**ZONING AMENDMENT,
PLANNED UNIT DEVELOPMENT &
SUBDIVISION STAFF REPORT**

| <u>SUBDIVISION NAME</u> | Mack Manufacturing Subdivision |
| <u>LOCATION</u> | 7205 Bellingrath Road (East side of Bellingrath Road, 2/10± mile South of Old Military Road) |
| <u>CONTEMPLATED USE</u> | Subdivision approval to create 1 lot, Planned Unit Development Approval to accommodate existing and future businesses and reduced front landscape requirements, and Rezoning from R-1, Single-Family Residential to I-2, Heavy Industry District, to accommodate existing and future businesses. It should be noted, however, that any use permitted in the proposed district would be allowed at this location if the zoning is changed. Furthermore, the Planning Commission may consider zoning classifications other than that sought by the applicant for this property. |

SITE PLAN

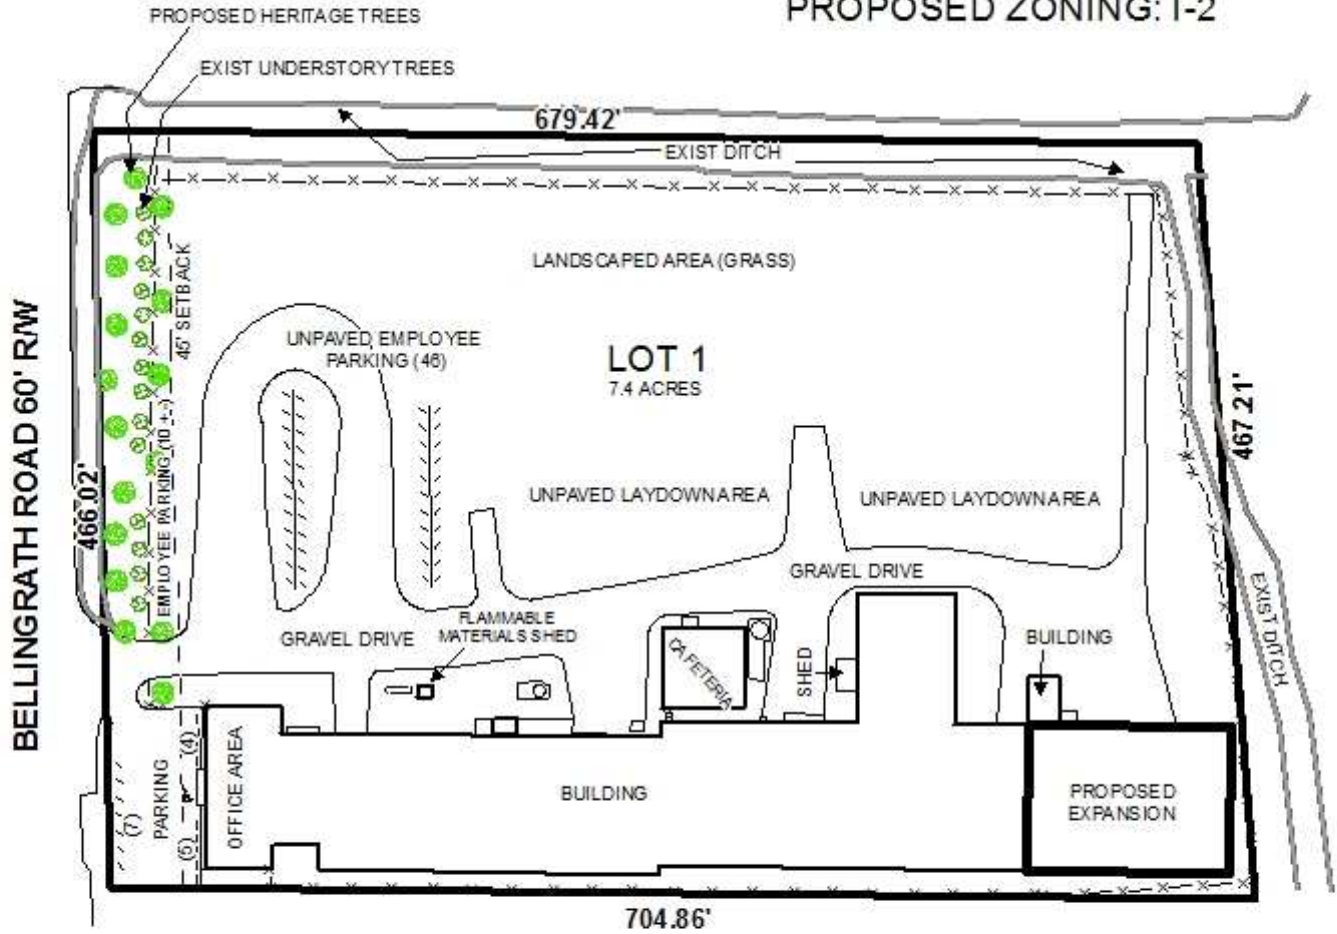
The site plan provided with the PUD application shows the existing buildings and the proposed expansion, as well as 73 parking spaces, proposed trees, landscape areas, and lay down yards.

The proposed expansion will come as close as approximately 6 \pm feet to the rear property line, abutting residentially-zoned property. While rear setbacks in an I-2 district can be 0 feet, where abutting residentially-zoned property, a 10-foot wide residential buffer must be provided. Therefore the proposed addition must be adjusted in size to be at least 10 feet from the rear property line: the existing buildings and proposed addition comply with all other setback requirements of the Zoning Ordinance. It should be noted that typically a 6-foot high wooden privacy fence is required as part of the 10-foot wide residential buffer, if shrubs are not provided. It appears that the site is fenced in with a chain link fence topped by strands of barbed-wire or similar. In lieu of a wooden privacy fence, the applicant may install screening slats within the existing fence for that portion of the site where new construction will be taking place along the

Of the 73 provided parking spaces, only 17 of them are on surfaces paved with asphalt or concrete: all other parking spaces and circulation areas are surfaced in aggregate, which is allowed by right in I-2 districts. The existing building includes a 4,100 square foot office area, however no information is provided regarding the number of employees in the remainder of the facility, so the total amount of required parking cannot be determined. The company's website states that they have 45 employees, thus a minimum of 29 spaces would be required.

Regarding tree and landscape compliance, the site plan depicts an existing row of Bradford pears, and 16 proposed heritage trees within the frontage area, however, only 15 heritage trees are required. The proposed heritage trees are depicted in the area that could possibly become right-of-way for Bellingrath Road, as well as within the 25-foot setback from the widened road. To facilitate future widening, the proposed heritage trees should be located in the 25-foot setback area, outside of any future right-of-way area.

For landscape area, the applicant states that they will be able to comply with the overall 12% landscape area requirement, but will fall short in the frontage landscape area requirement due to the existing development of the site within the frontage area. It also appears that the frontage landscape area calculations provided by the applicant includes the future right-of-way area, which if removed from the calculations, results in a dramatic shortage of front landscape area. Planned Unit Development review gives the Planning Commission some flexibility regarding site design, and the Commission may wish to limit the front landscape area requirement to what is practicable, subject to compliance with the total landscape area requirements on the site. It is recommended that any area identified as landscape area be protected from vehicular or lay down yard intrusion through the use of parking bumpers, landscape timbers, or similar.

No dumpster is depicted on the site plan. If a dumpster is used on the site, it must be depicted on the site plan. New dumpsters placed on the site must comply with Section 64-4.D.9. of the Zoning Ordinance.

Finally, no sidewalk is depicted on the site plan and a sidewalk waiver request has not been submitted. Either a sidewalk must be provided along Bellingrath Road, or an application should be submitted for a sidewalk waiver.

- 1) Revision of the site plan to adjust the location of the proposed expansion to be a minimum of 10-feet from the East and South property lines;
- 2) Revision of the site plan to depict the 10-foot protection buffer required by Section 64-4.D.1., and labeling of the area where fence screening will be provided adjacent to the new construction along the East and South property lines;

- 3) Placement of a note on the site plan stating that future residential development adjacent to the site will require full compliance with the buffering requirements of Section 64-4.D.1. where this site abuts residential uses;

- 4) Provision of 15 heritage trees within the 25-foot setback area, adjusted for the future widening of Bellingrath Road;
- 5) Provision of the total required landscape area on the site, with the provision of as much frontage landscape area as possible outside of the future right-of-way area, and revision of the frontage landscape area calculations;

- 6) Protection of any landscape areas counted for compliance with parking bumpers, landscape timbers or similar, to prevent encroachment by vehicles or lay down yards;

- 7) Depiction of any existing dumpsters on the site plan, and placement of a note on the site plan stating that new dumpsters placed on the site must comply with Section 64-4.D.9. of the Zoning Ordinance;

- 8) Depiction of a sidewalk along Bellingrath Road, or submission of a sidewalk waiver request prior to any request for permits for new construction;
- 9) Retention of the 45-foot setback line on the site plan;
